Re: Additional Information to Control Number 586692 – Remaining Pickard Hall SCP RAIs

**Remaining University of Missouri, Pickard Hall Site Characterization Plan  
Requests for Additional Information**

**Appendix B:**  
**Sewer and Underground Utility**  
**Drawings**

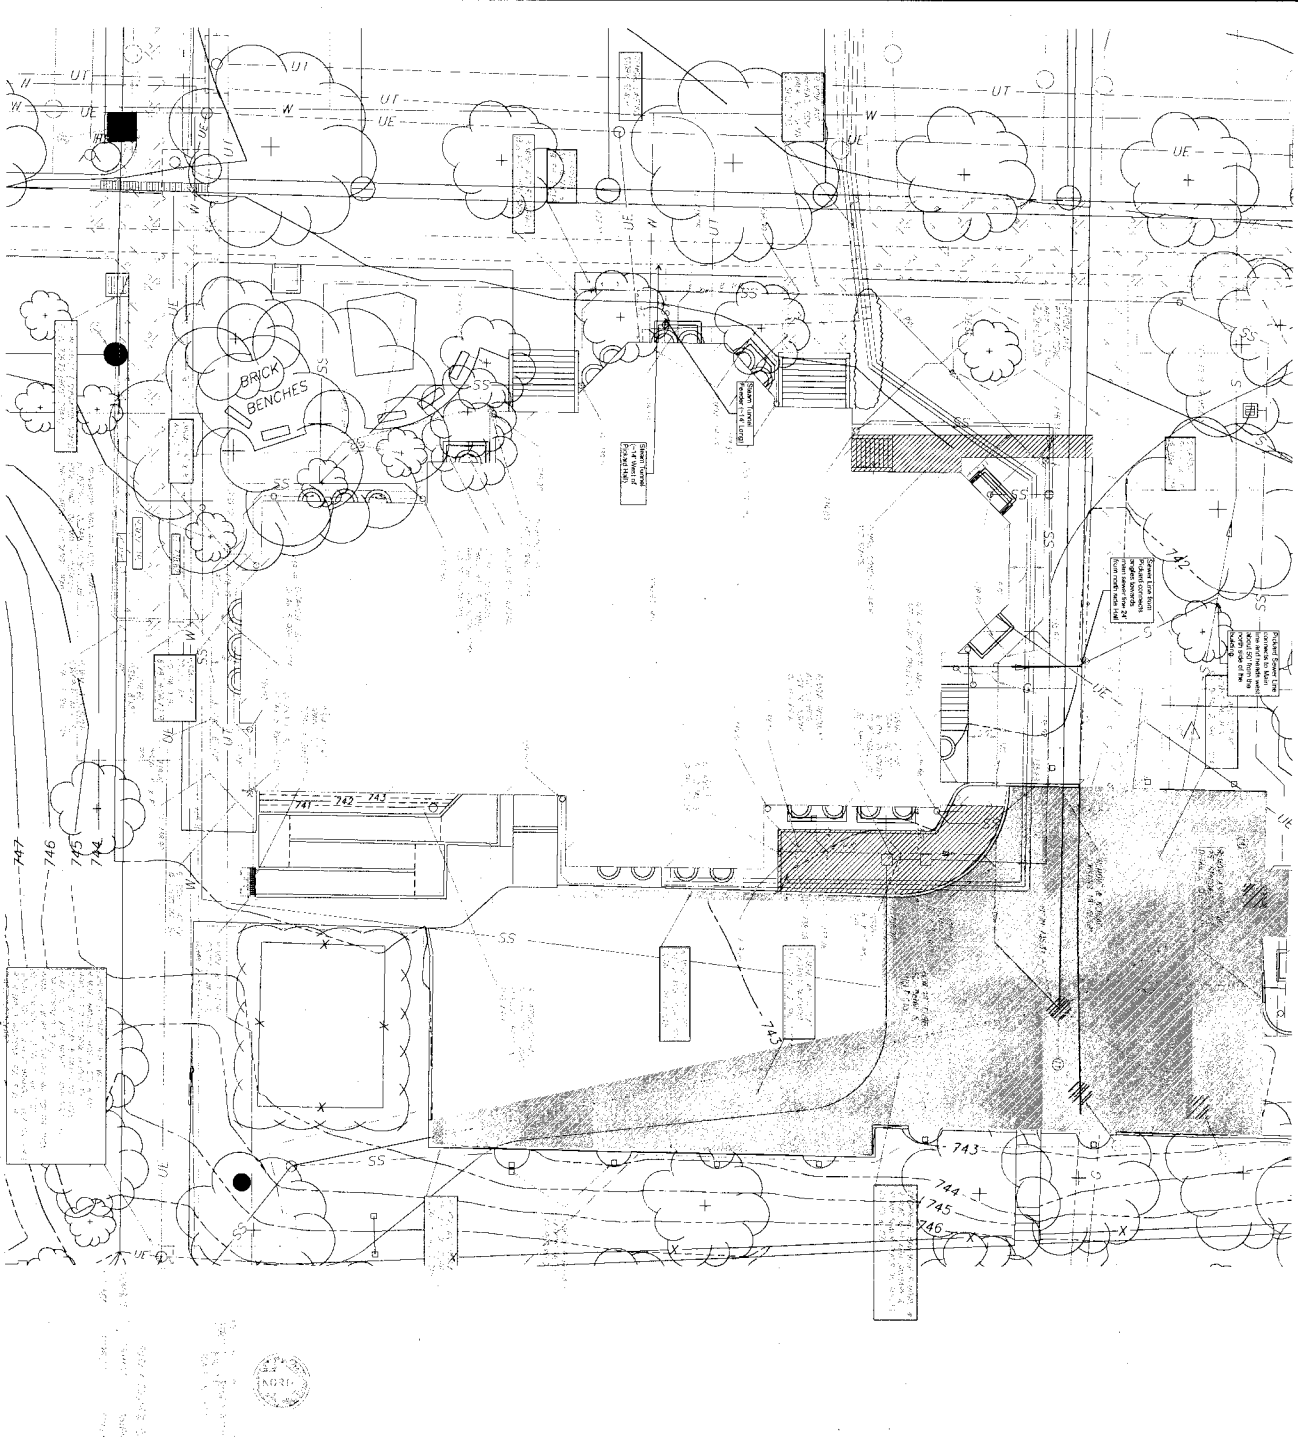
Request from the US NRC: The NRC requested the licensee provide a commitment to scan the entire underground piping associated with radioactive contamination and *submit diagrams of piping which is to include, but not limited to, sanitary drain lines and steam/feeder tunnels.*

Response from the University of Missouri: Please see Appendix B which includes the sewer and underground utility drawings. Drawing 960405-1-C12-Layout1, *Pickard Utility Layout 1997*, has been annotated to show the sewer line exiting Pickard Hall and the Steam Tunnel Feeder Tunnel. The drawing also annotates where the sewer line and Feeder Tunnel connects to their respective main sewer line and steam tunnel.
